AW-97-1118

June 10, 1997

SUBJECT: RESPONSES TO OPEN ITEMS ON WCOBRA/TRAC APPLICABILITY TO
AP600 LARGE-BREAK LOSS-OF-COOLANT ACCIDENT

Predicted vessel mass for UPTF test 136

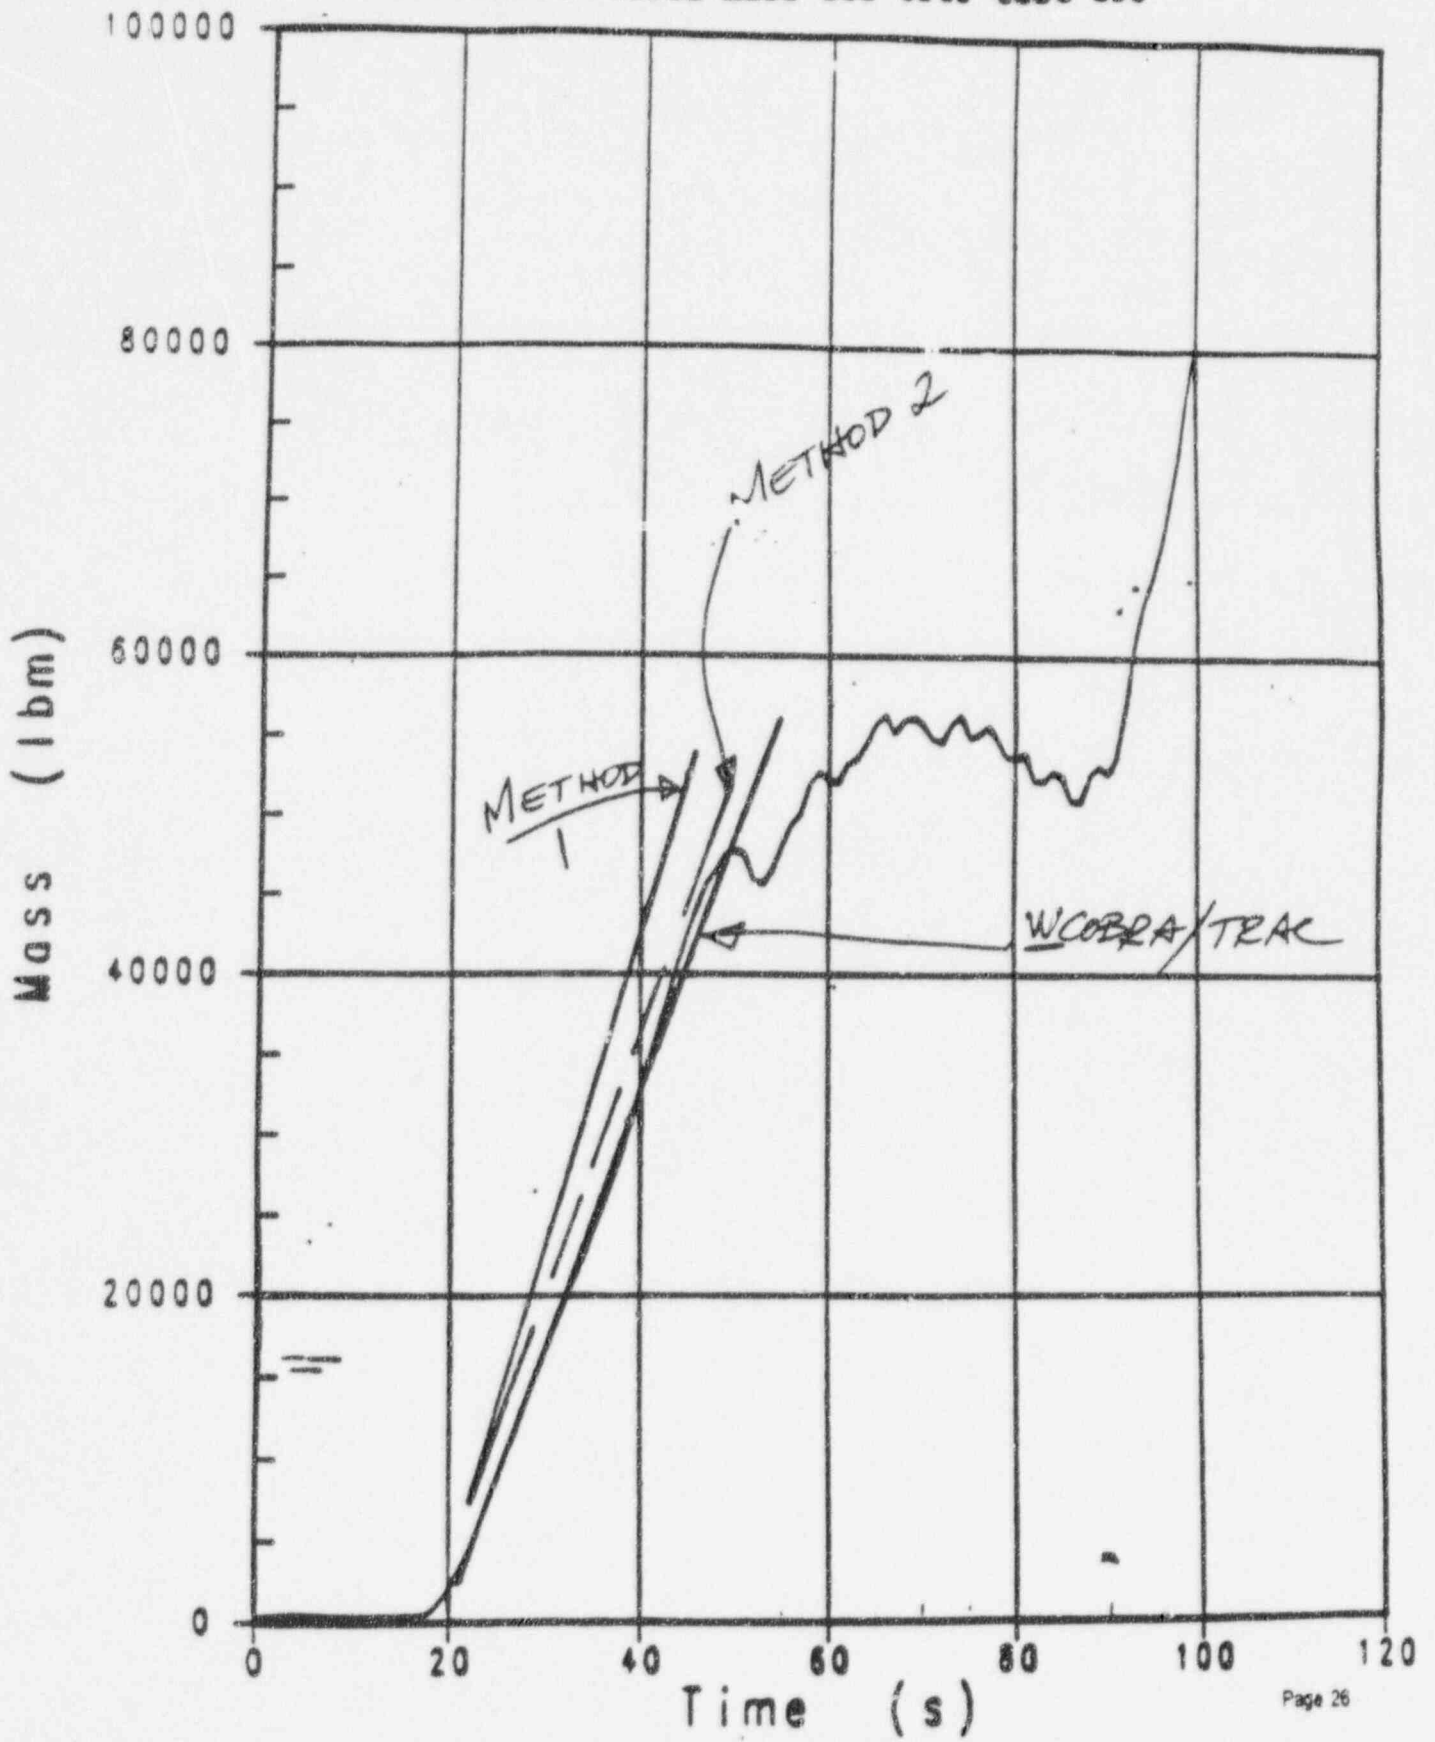
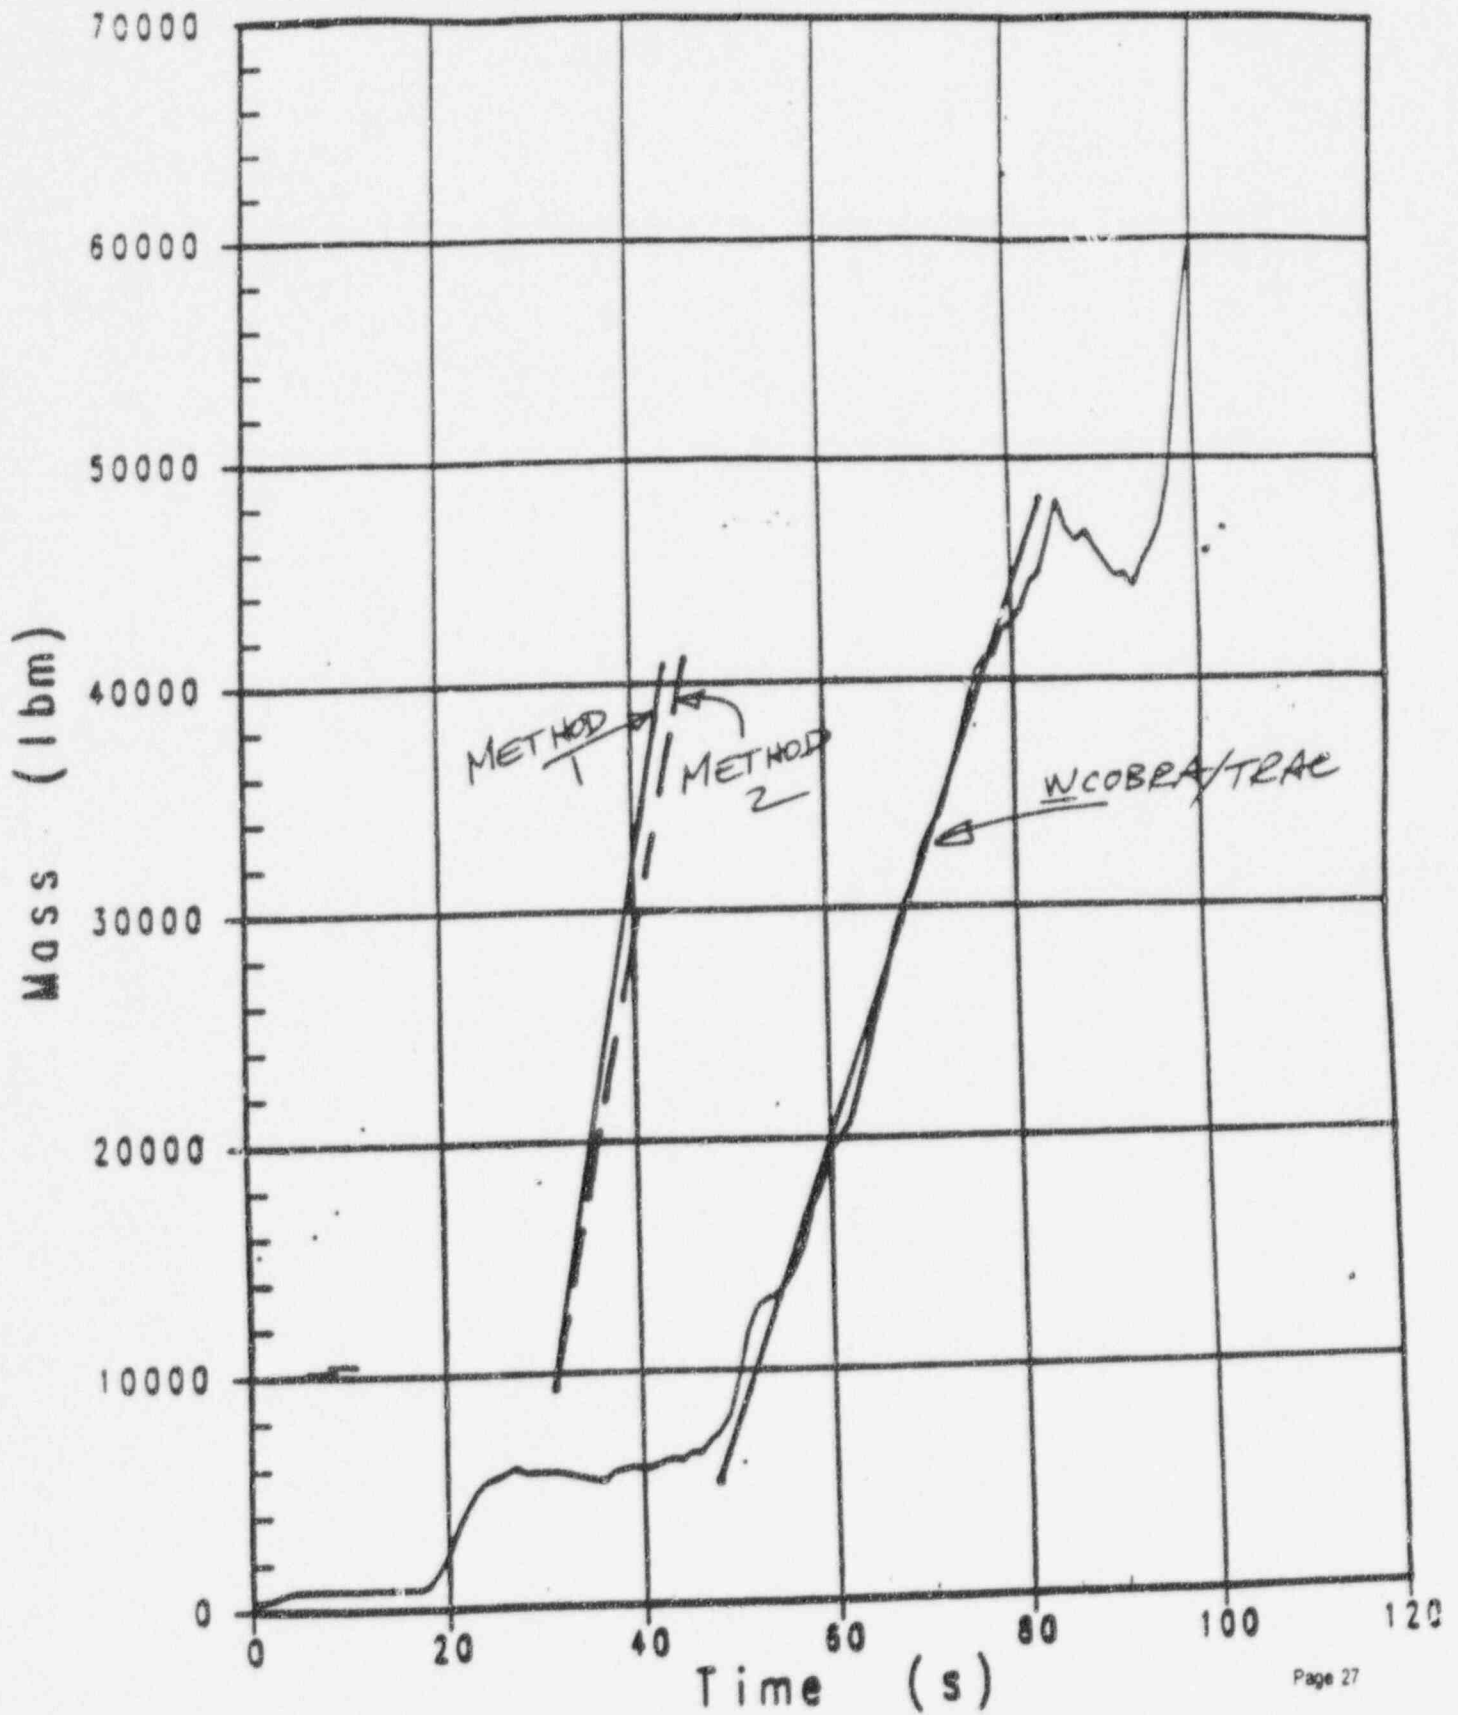
- f. On page 3-82 Westinghouse stated that WCOBRA/TRAC predicts the different flow behavior that results from cold leg or downcomer injection. In Test 21, ECC water breakup on the downcomer wall resulted in greater bypass relative to UPTF Test 6 (see page 3-82). This implies that the WCOBRA/TRAC calculated bypass for Test 21 should be greater than the WCOBRA/TRAC bypass calculated for UPTF Test 6. Provide the calculated ECC bypass results for Tests 6 and 21 that support this argument. This also implies that the conservatism of the WCOBRA/TRAC ECC bypass results for UPTF Test 21 should be greater than the conservatism of the WCOBRA/TRAC ECC bypass results for Test 6. Clarify if this is true.

The attached figures (from Reference 8f-1) show the measured and WCOBRA/TRAC-predicted vessel mass inventories for the two UPTF Test 6 runs. In each figure, the dashed line superimposed is the refilling determined (method 2) from the vessel refill rate, and the solid line superimposed is the refilling identified from a mass balance (method 1). WCOBRA/TRAC predicts a delayed refilling for Run 132 by about 20 seconds, and it predicts the refilling of Run 136 well.
